STAFF RECOMMENDATION 1416 Fourth Avenue North January 21, 2015

Application: Signage
District: Germantown Historic Preservation Zoning Overlay
Council District: 19
Map and Parcel Number: 08209010000
Applicant: Powell Architecture + Building Studio
Project Lead: Allison Asbrock, robin.zeigler@nashville.gov

Description of Project: The applicant proposes to install a partial perimeter fence and two signs to the front addition of the building at 1416 Fourth Avenue North. The addition was approved in April 2014.

1 West Elevation-MDHA rev1
1/8" = 1'-0"

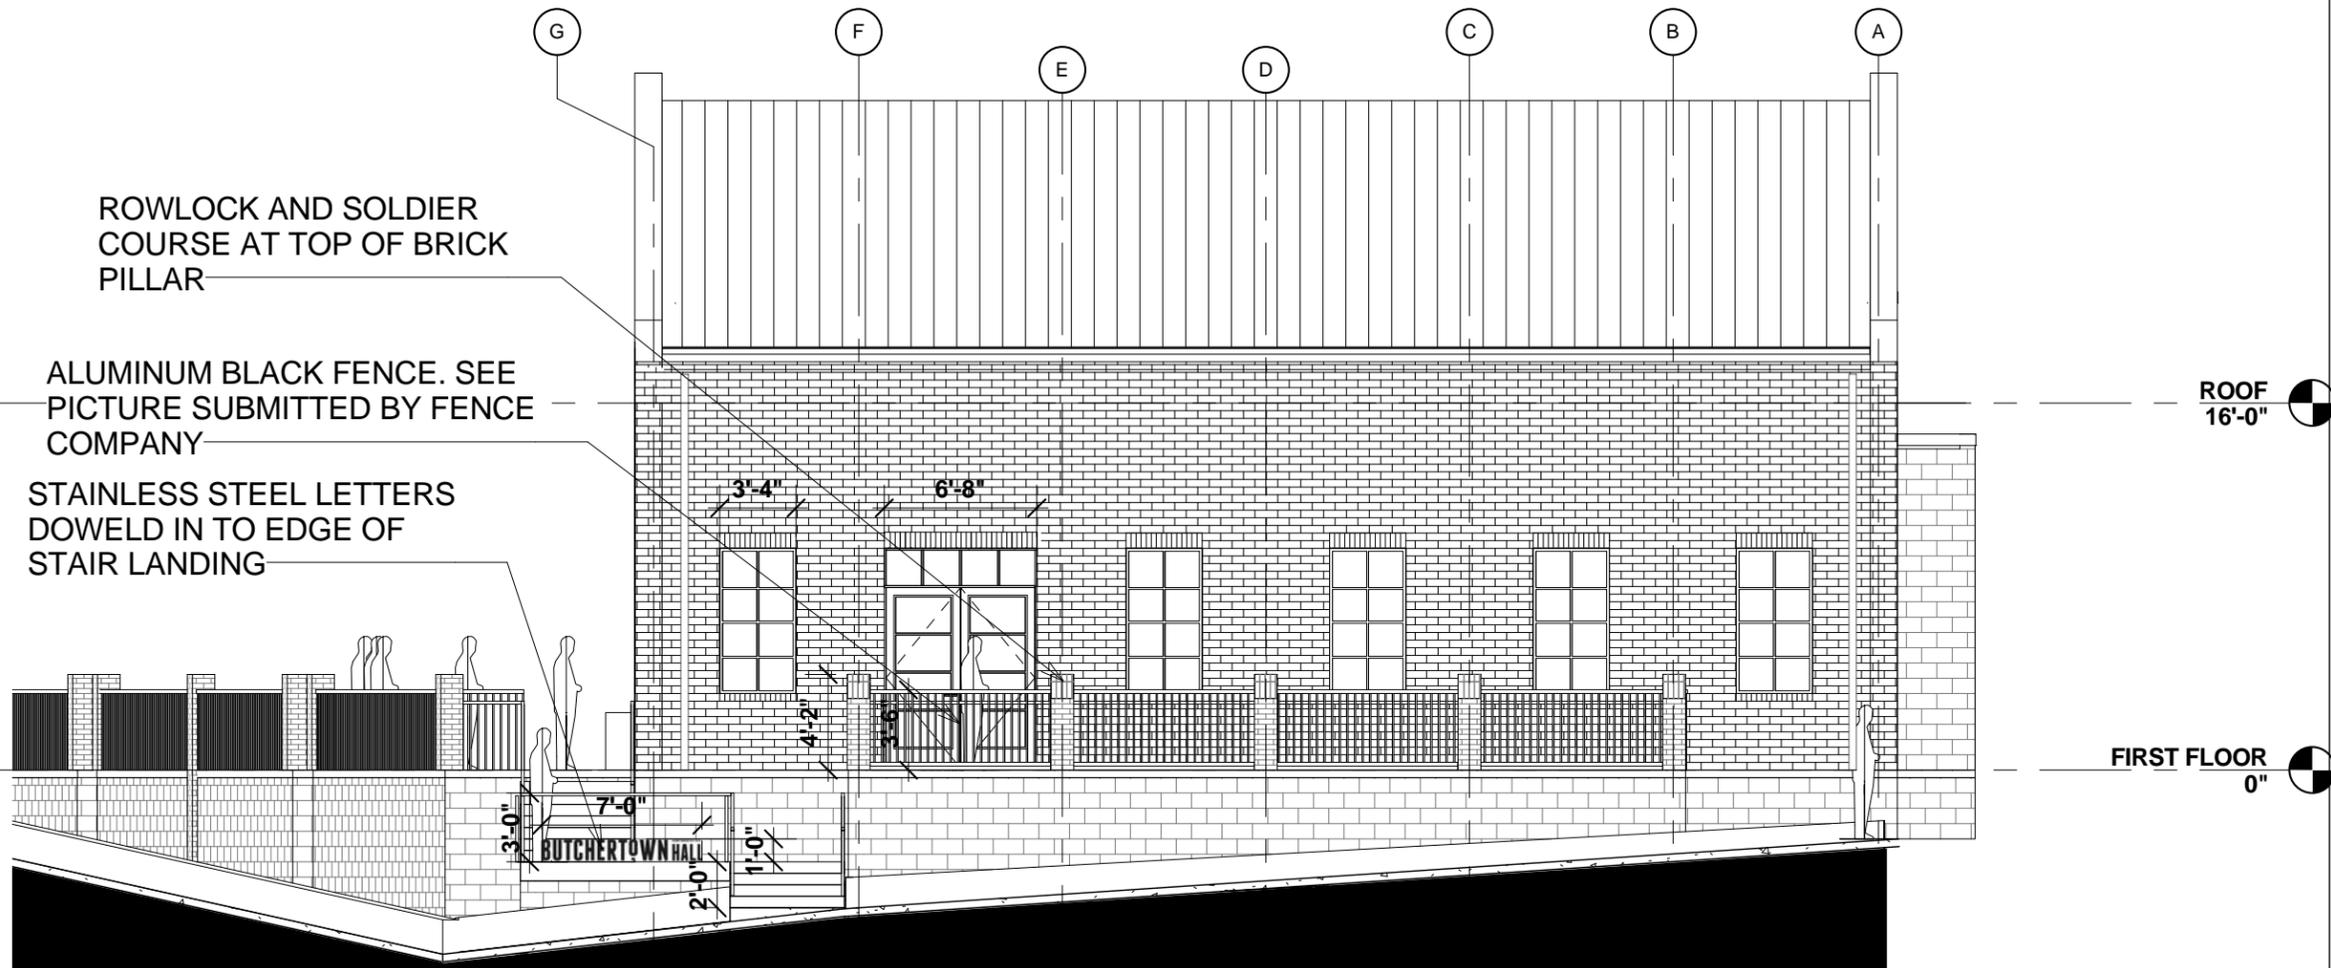
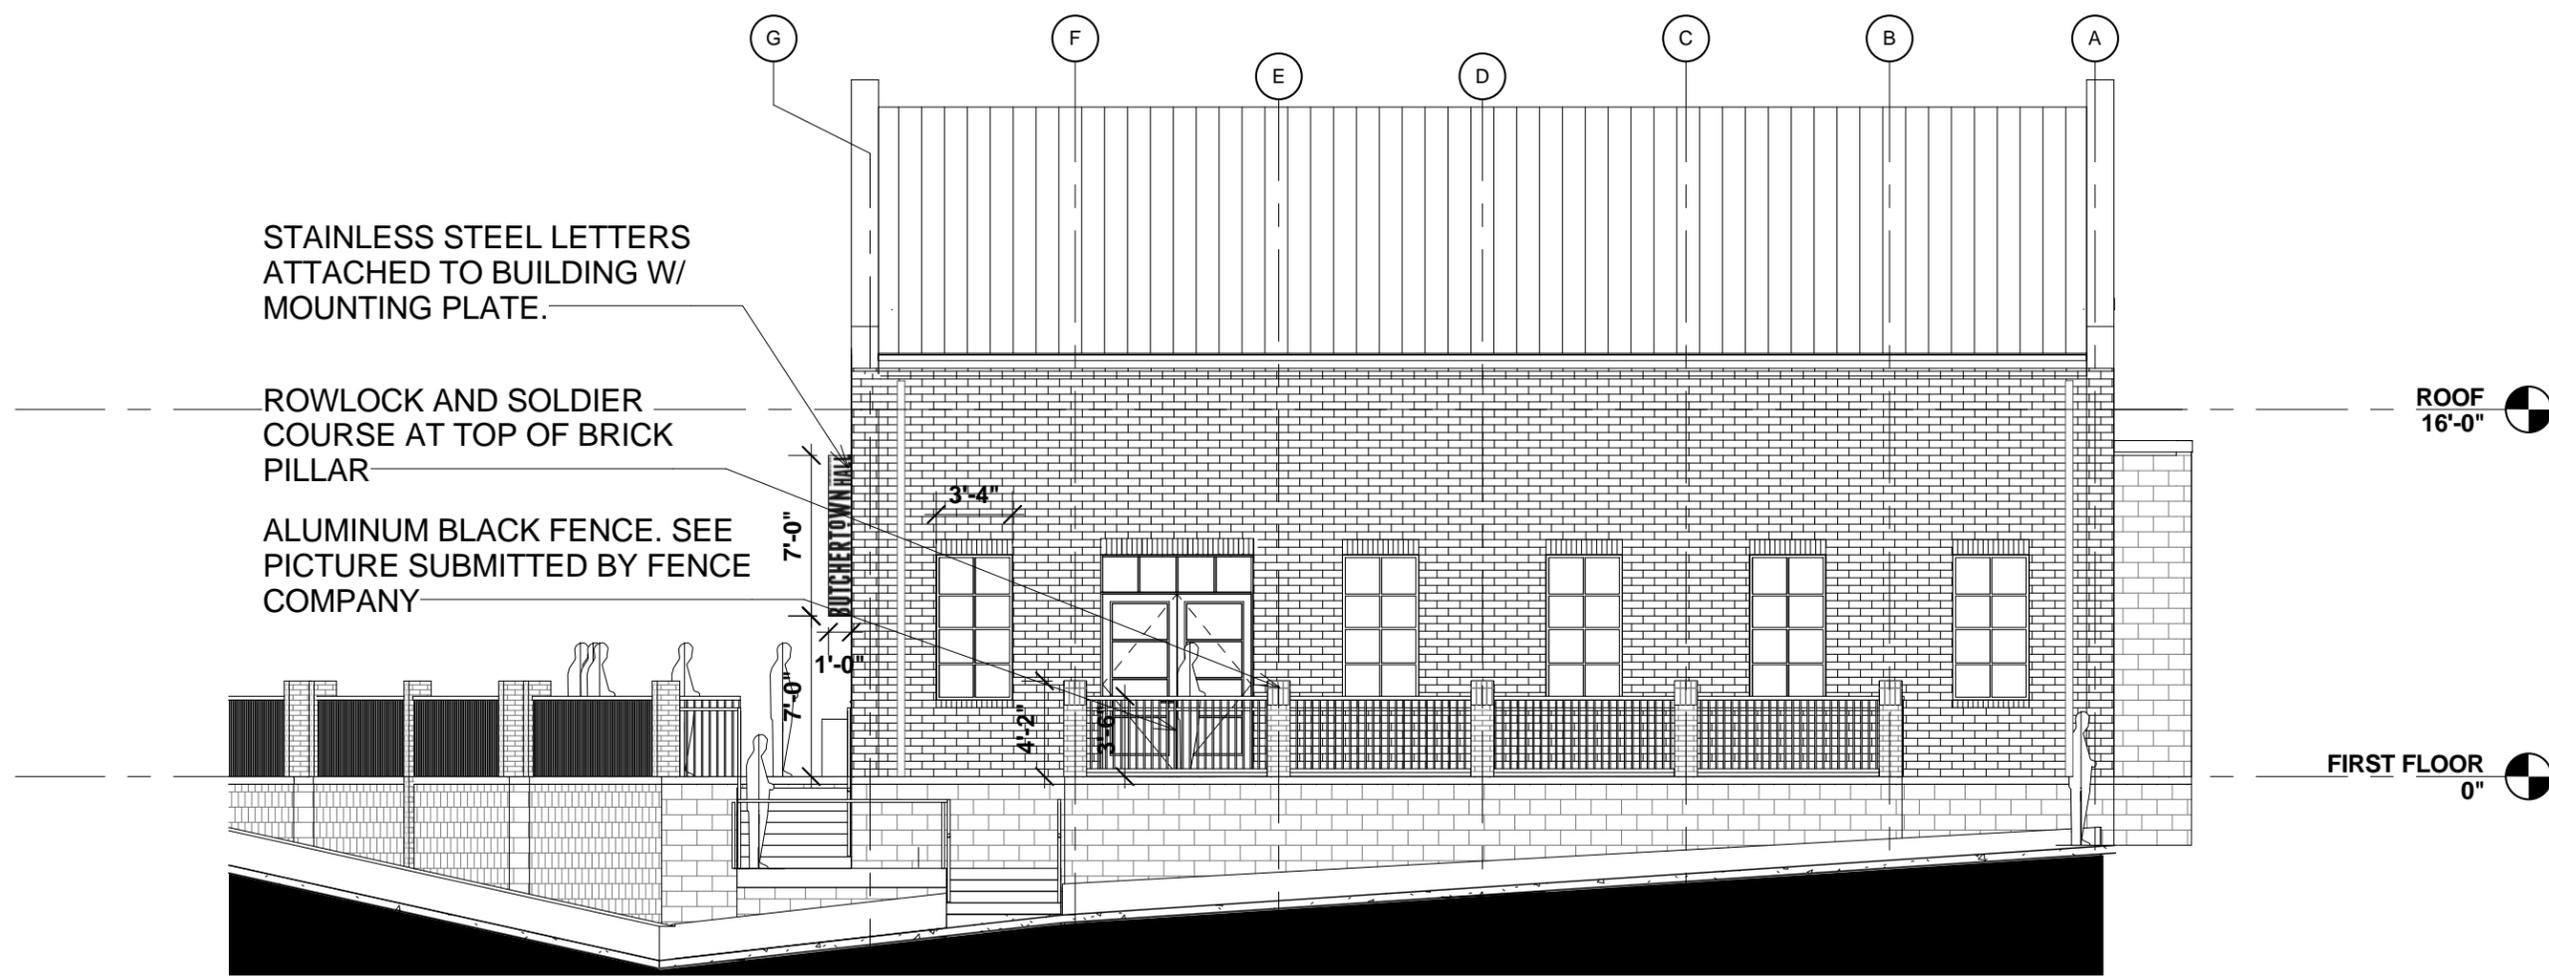
The proposed fence is a black aluminum fence at a height of three feet and six inches (3' 6"). The applicant has submitted images of the proposed fence and hand rail. Staff finds the fence to be appropriate in design as the fence provides a transparency that does not add to the massing of the masonry walls (Figure 2).

The blade sign is located on the north façade at the corner of the building seven feet (7') from the finished floor and is an appropriate location.

The monument sign faces Fourth Avenue North and is located on the first landing of the concrete stairs. This location is not a typical historic location for signage and doesn't meet the design guidelines for monument signs; however staff finds it to be appropriate as the sign is integrated into the design of the railing and the steep grade of the lot creates unique circumstances. The sign will be more visible to the pedestrian than the only other option which would be a wall sign. Therefore, Staff feels that the location of the sign at approximately three feet, six inches (3' 6") from grade is an appropriate location given the constraints of the lot.

Both signs are steel signs. The guidelines indicate that metal signs should be painted. Staff finds the use of un-painted steel to be appropriate as the unfinished metal will complement and blend with the fence and railings.

The proposed blade sign is approximately seven square feet (7 sq. ft.) and meets the guidelines as the maximum is sixteen square feet (16 sq. ft.). The blade sign also meets the guidelines for projection depth as the maximum projection is three feet (3') and this sign projects only one foot (1'). Thickness of the sign was not noted on the plans.

The monument sign is the same dimensions as the blade sign, seven feet (7') wide and one foot (1') tall. The thickness of this sign also is not indicated.

Staff finds the blade sign and the monument sign to meet section 8.3 with the condition that the widths of the signs be no more than three inches (3").

Landscape lighting is proposed that would illuminate the railing sign. Provided that the lighting fixture is approved by staff prior to purchase and installation, the light be screened from public view, and the light is focused only on the monument sign, staff finds the installation of the fixture to meet section 5.4 and 8.5 of the design guidelines.

- The widths of the signs be no more than three inches (3").
- The lighting fixture is approved by staff prior to purchase and installation, is screened from public view, and is focused only on the railing sign.
